Theater Missile Defense Extended Test Range

Final
Environmental Impact Statement

November 1994

Volume I begins with the Executive Summary and Acronyms and Abbreviations. Section 1.0 of the Final EIS contains the introduction. Section 2.0 contains the additions and revisions to the Draft EIS and to the Supplement to the Draft EIS. Section 3.0 contains the responses to comments that were made on the two documents, and Section 4.0 includes an index to the commenters. Section 5.0 contains the agency comment letters and responses that pertain to the Draft EIS and the Supplement to the Draft EIS, while Section 6.0 lists the references used in the preparation of the Final EIS. Section 7.0 contains the list of preparers of the EIS, and Section 8.0 contains the distribution list for the document. Section 9.0 contains copies of the transcripts, exhibits, and written comments pertaining to the Draft EIS relevant to the Western Range Candidate Test Area. Section 10.0 contains copies of the transcripts, exhibits, and written comments pertaining to the Draft EIS relevant to the Eglin Air Force Base Candidate Test Area. Appendix A contains a discussion of cumulative impacts for the EIS, and Ap

Figure 2.2-2

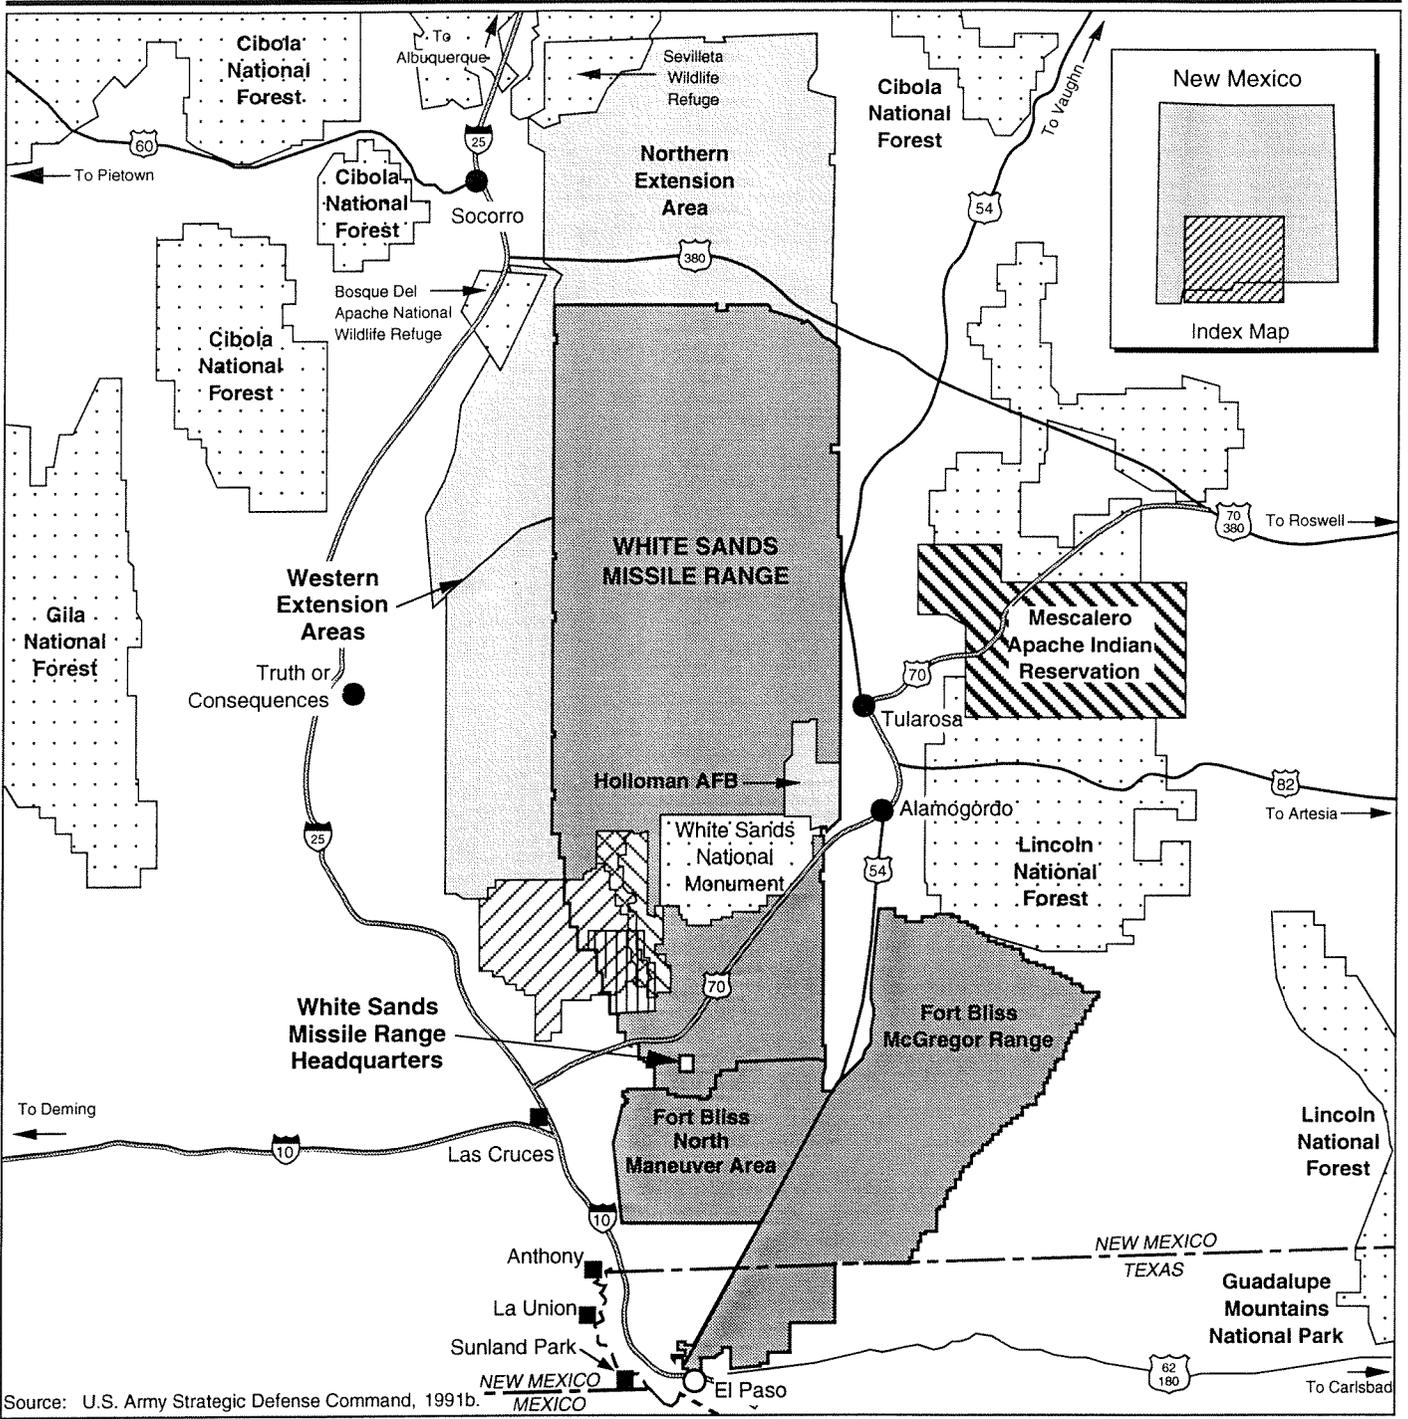
Page 2-35, figure 2.2-2: Figure has been revised as shown.

Figure 2.2-7

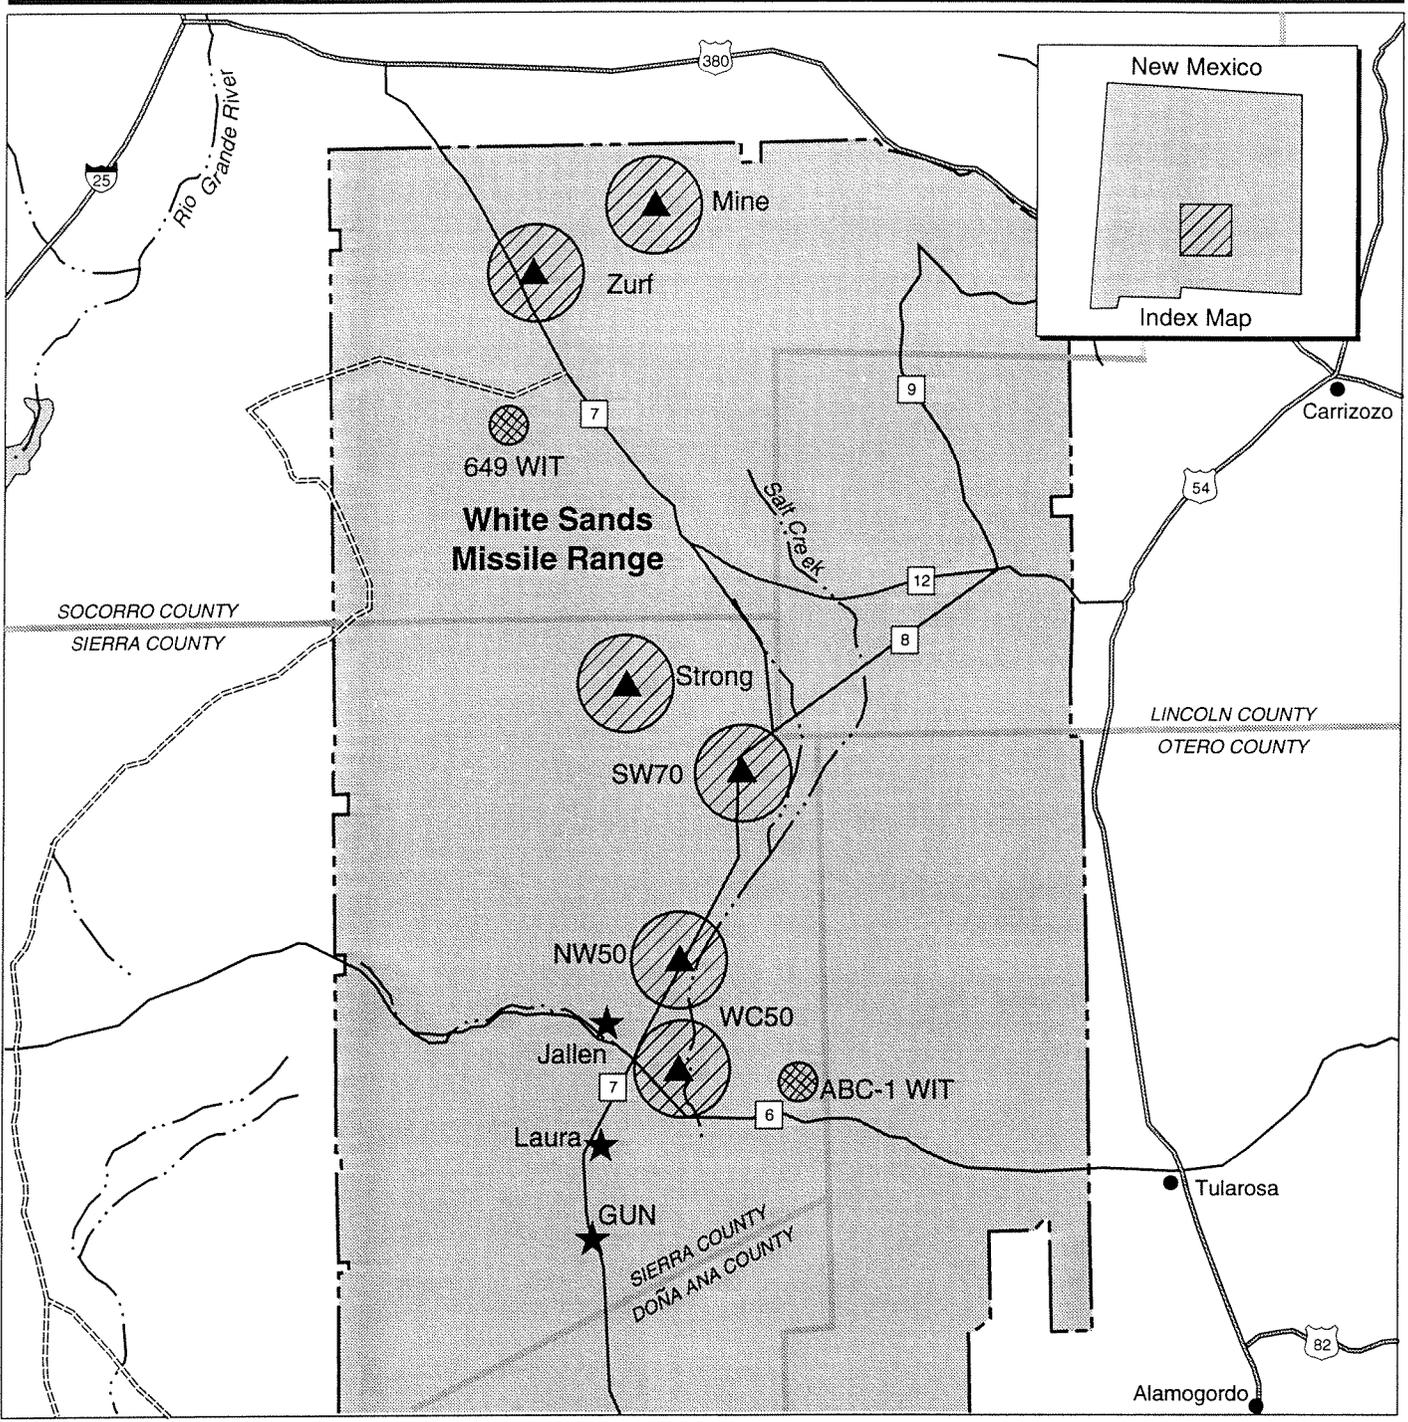
Page 2-45, figure 2.2-7: Figure has been revised as shown.

Figure 2.2-11

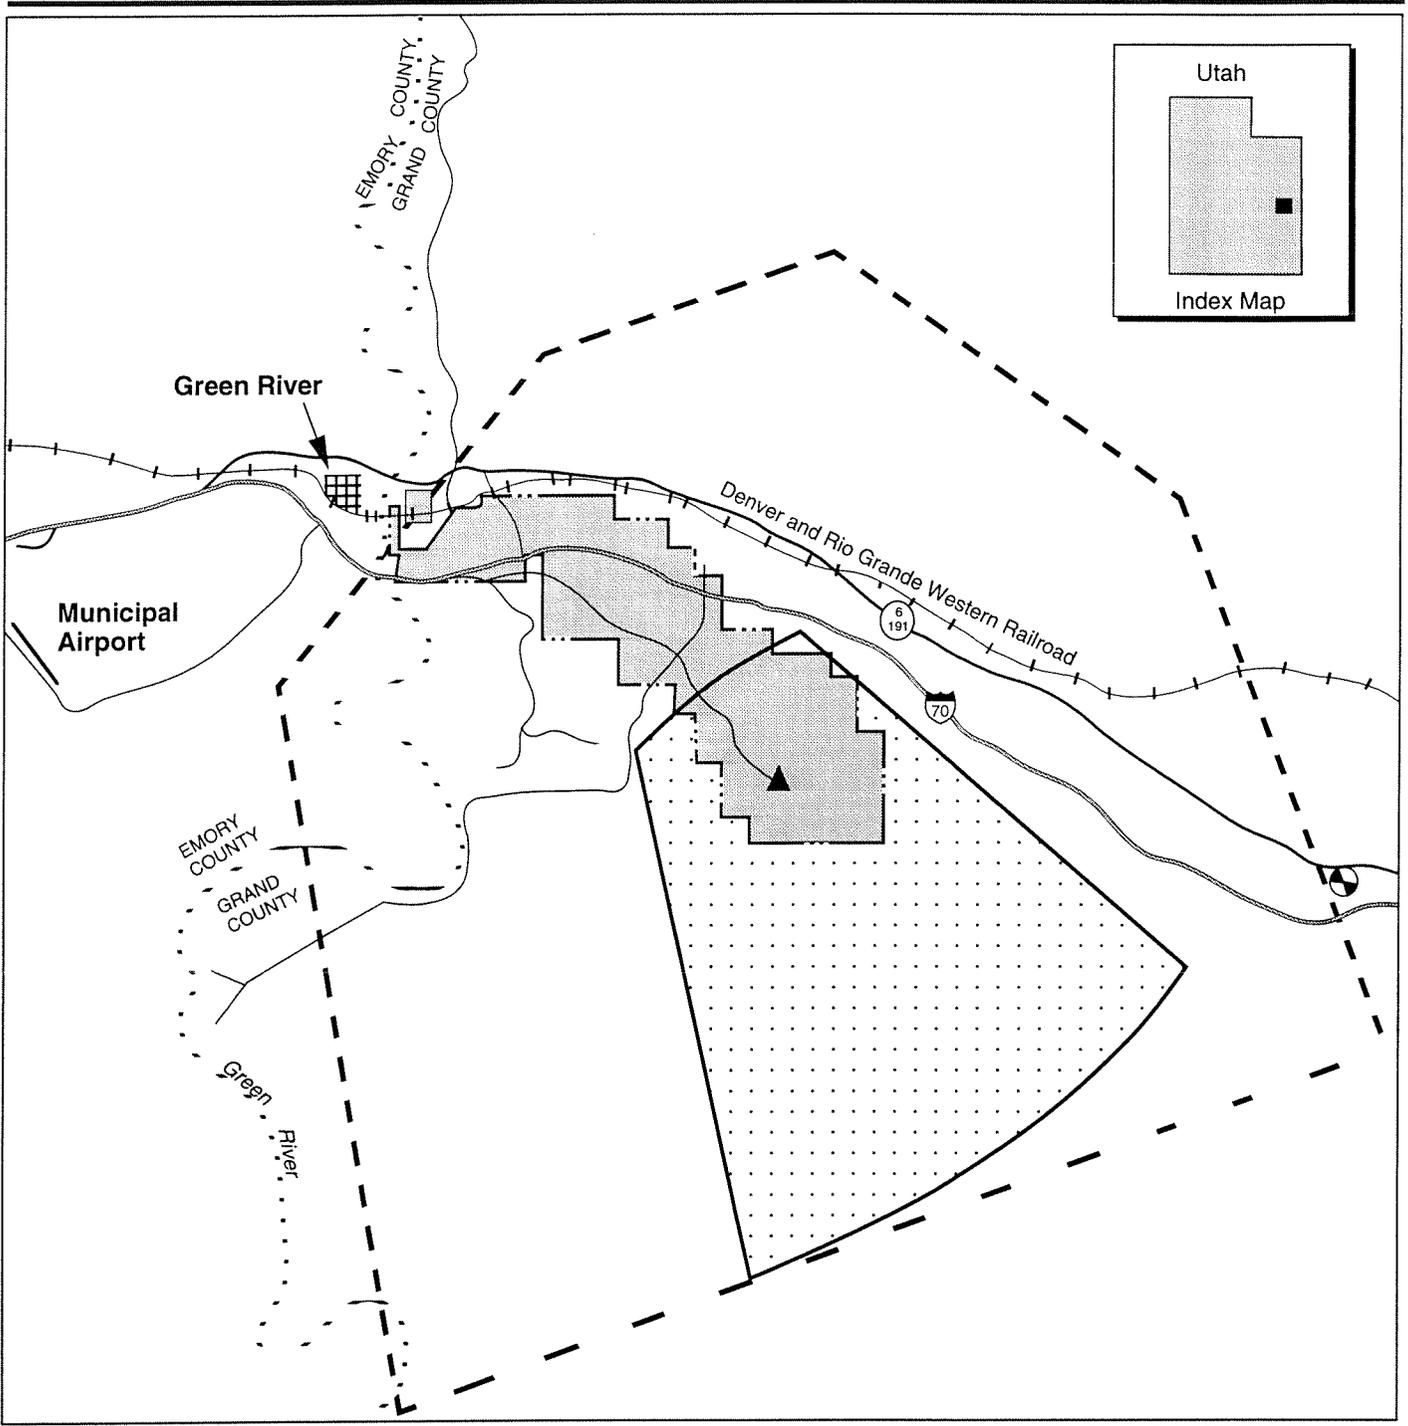
Page 2-50, figure 2.2-11: Figure has been revised as shown.

Figure 2.2-12

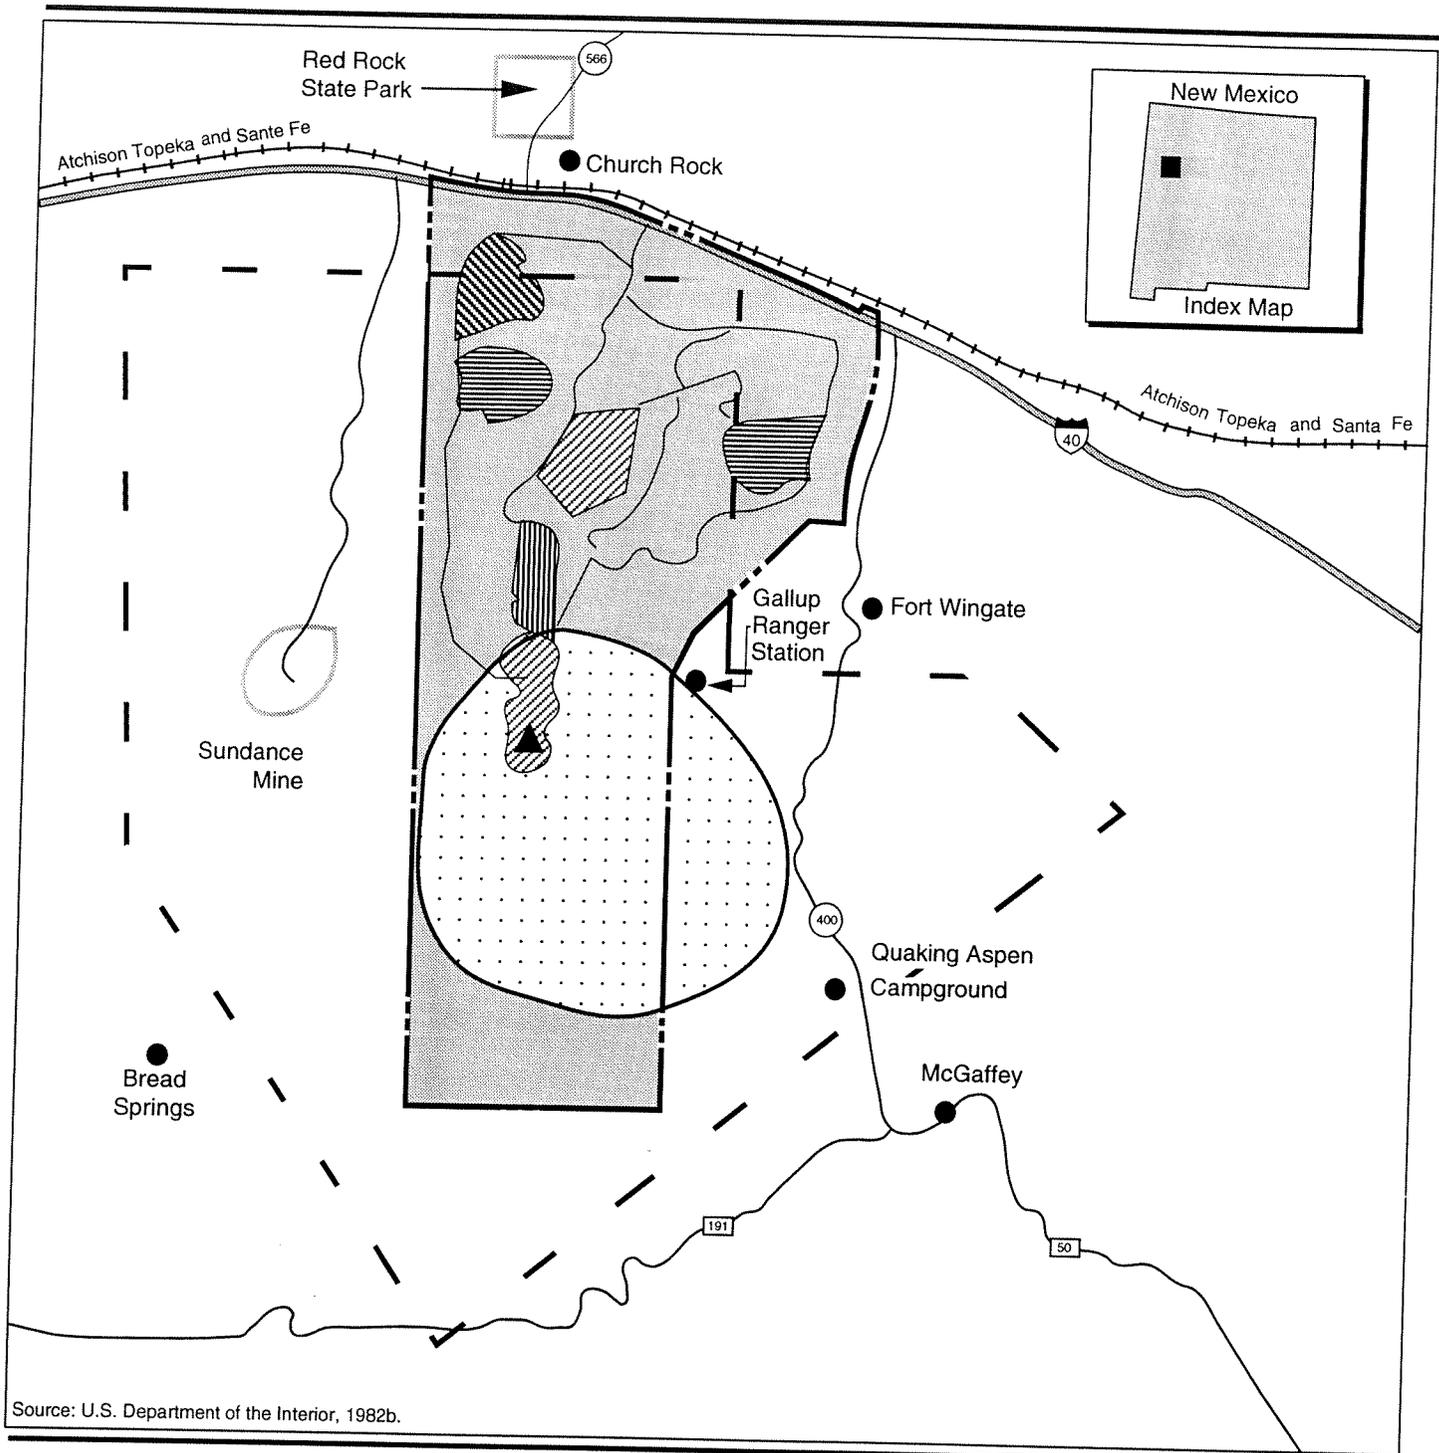
Page 2-51, figure 2.2-12: Figure has been revised as shown.

Figure 2.2-13

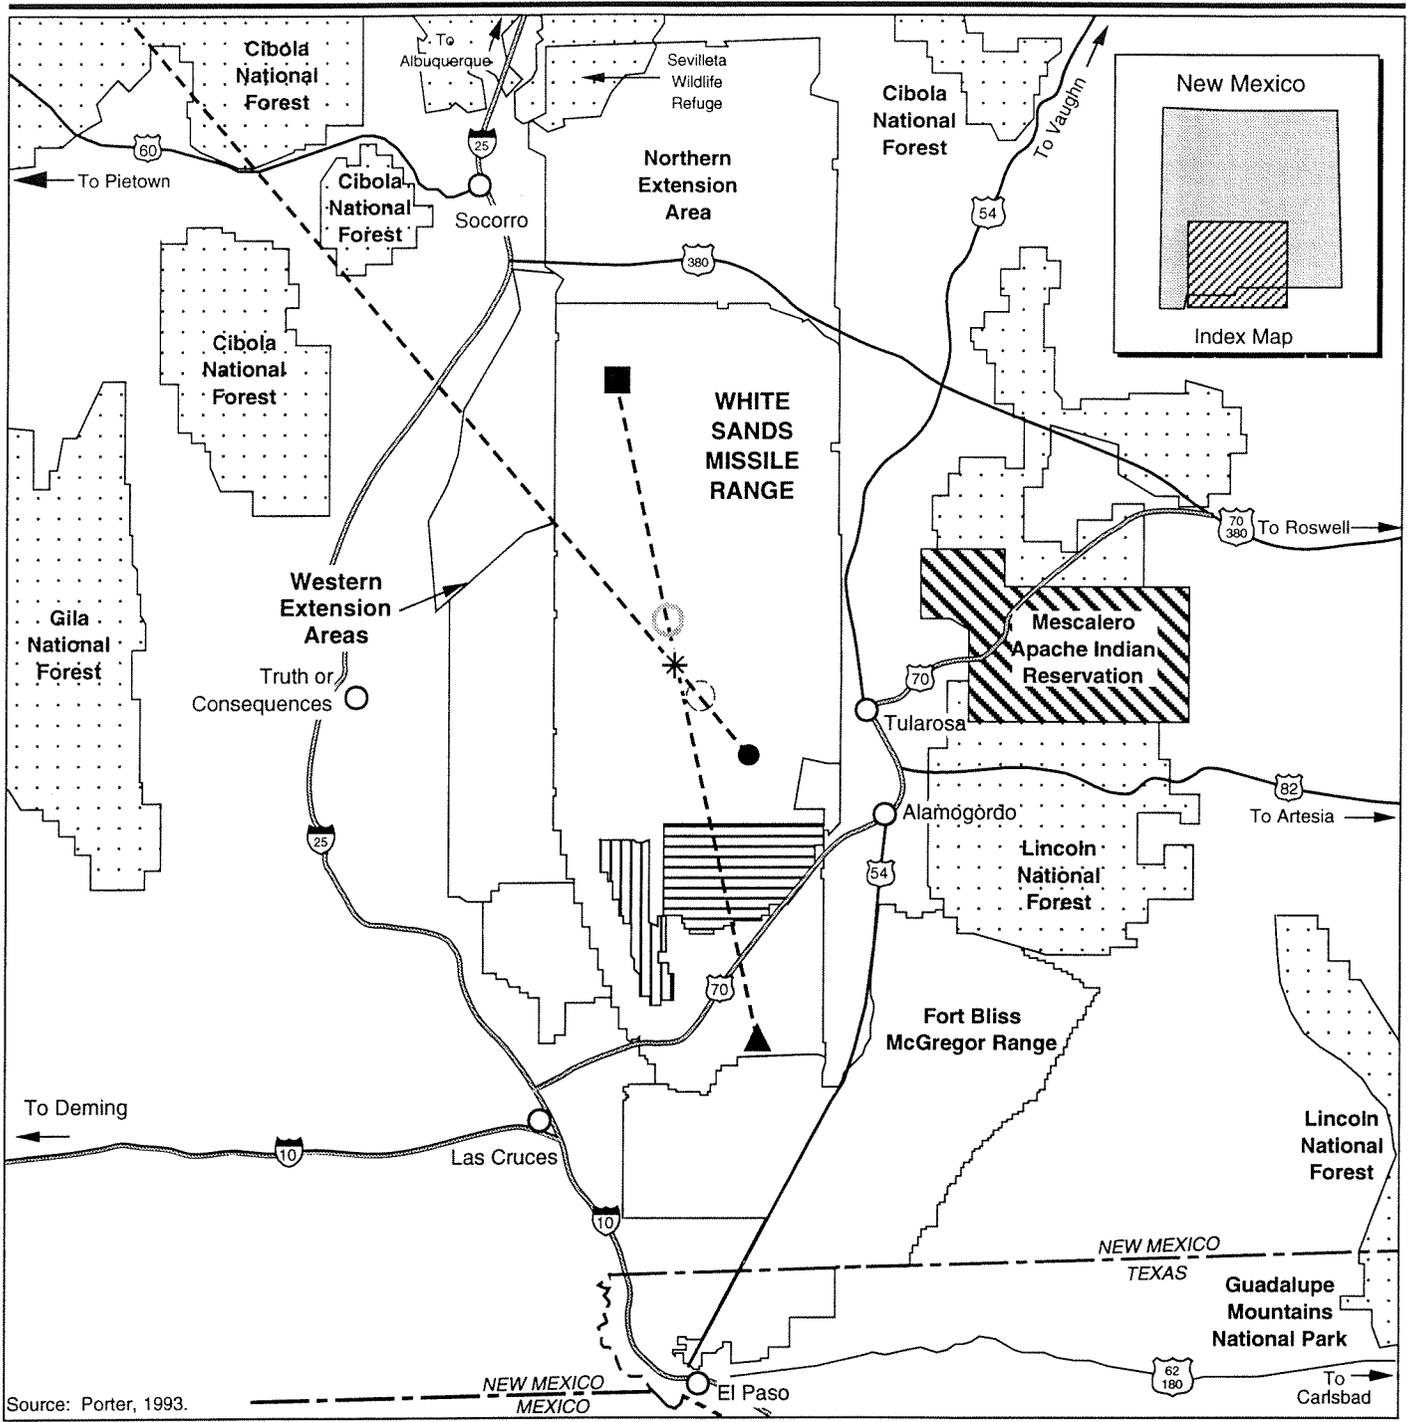
Page 2-55, figure 2.2-13: Figure has been revised as shown.
